**International
Aero Engines**

V2500 Propulsion System — Nacelle

Subject: Transmittal of Revision 2 to Service Bulletin Number V2500-NAC-75-0058

NACELLE - EXHAUST - SEAL, ACAC DUCT -
REPLACEMENT OF

Removal Of ACAC Duct Flange.
Figure 1.

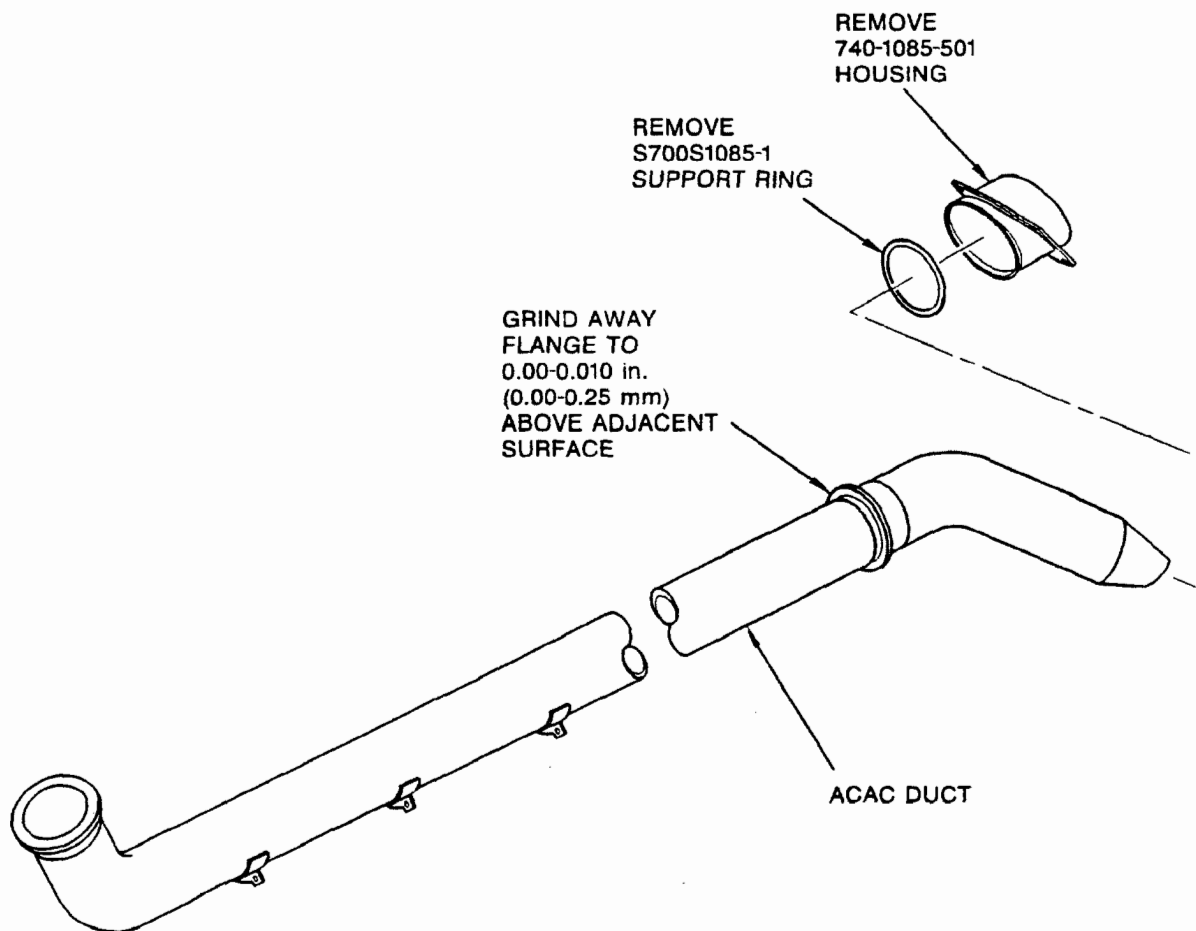
- (1) Remove the 740-1085-501 housing and S700S1085-1 support ring from the ACAC duct. Discard the support ring. Refer to Figure 1.
- (2) Remove the flange from the duct with a grinder so that any remaining flange material is no more than 0.010 inch (0.25 mm) above the adjacent surfaces of the duct. Refer to Figure 1. Remove all burrs and sharp edges.

ACAC Exhaust Duct Housing Modification
Figure 2.

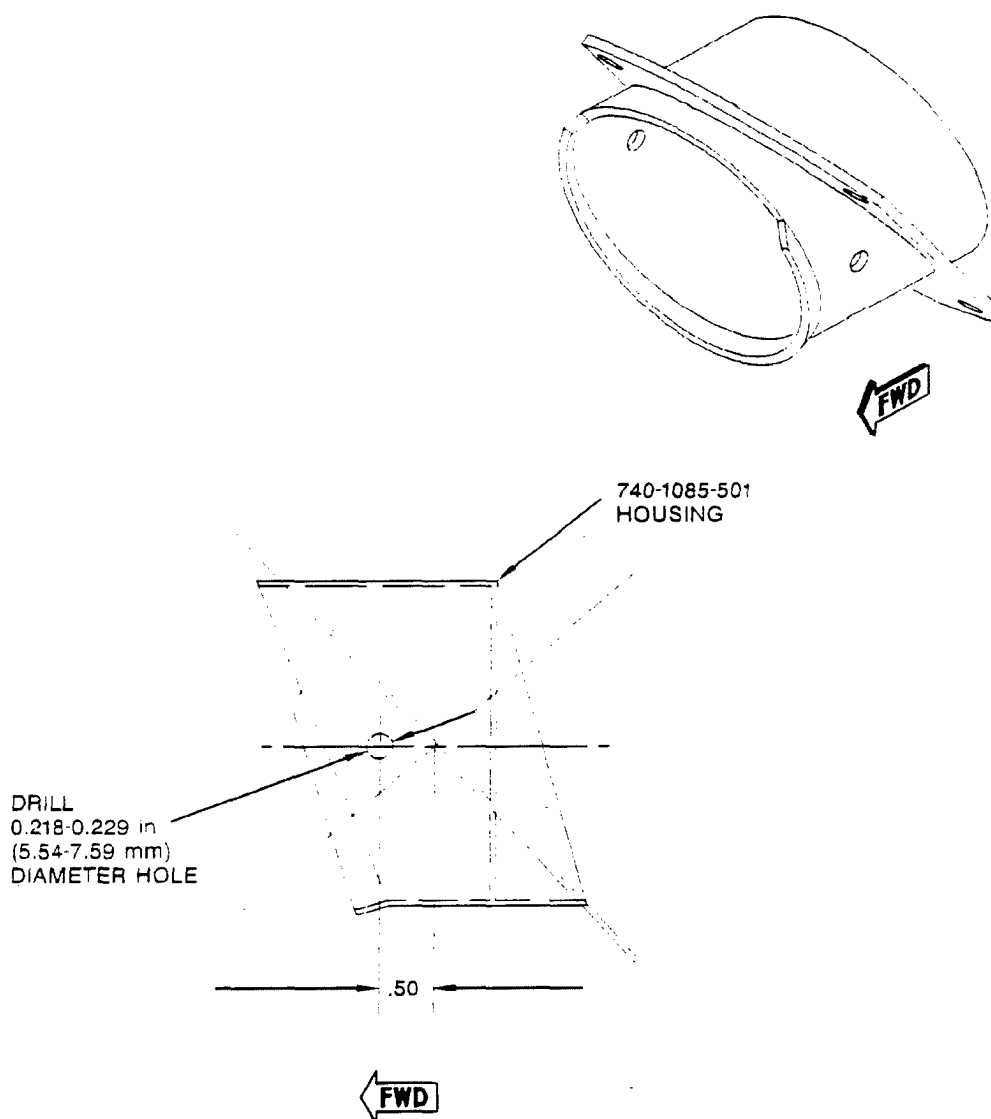
- (4) Mark two hole locations on the 740-1085-501 housing. Refer to Figure 2.
- (5) Drill two 0.218-0.229 inch (5.54-5.82 mm) holes in the 740-1085-501 housing at the marked locations. Remove the burrs from the drilled holes.

Support And Backup Ring Installation
Figure 3.

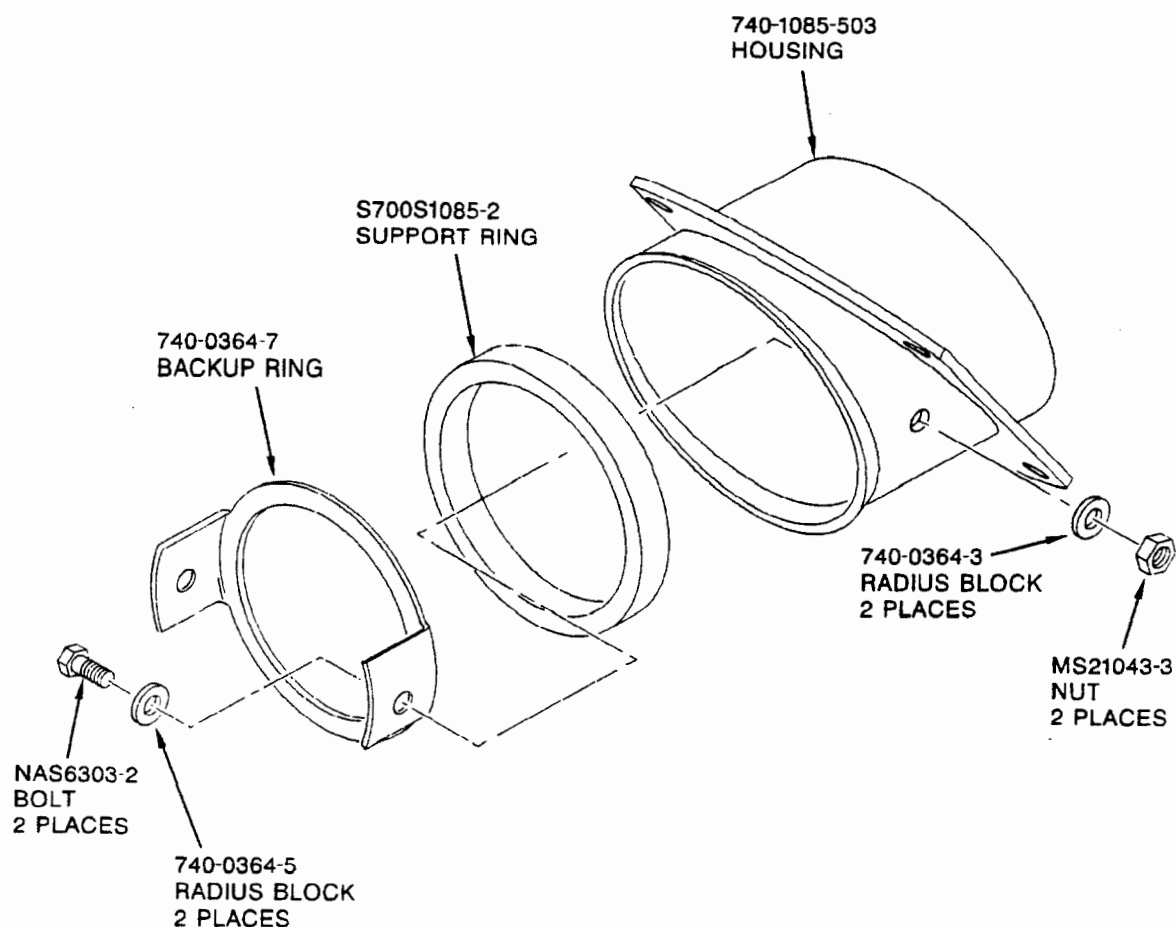
- (8) Install the 740-1085-503 housing and 740-0361 ACAC exhaust duct into the common nozzle assembly . Refer to the A320/A321 Aircraft Maintenance Manual, Chapter 78-11-11, page block 401.
- (9) Put the S700S1085-2 support ring in the 740-1085-503 housing. Refer to Figure 3.
- R (10) Put the 740-0364-7 backup ring in the 740-1085-503 housing.
- R (11) Put the two 740-0364-5 radius blocks in the 740-1085-503 housing. Put the two NAS6303-2 bolts thru the 740-0364-5 radius blocks, 740-0364-7 backup ring, and the 740-1085-503 housing. Install the two 740-0364-3 radius blocks and MS21043-3 nuts on the NAS6303-3 bolts.
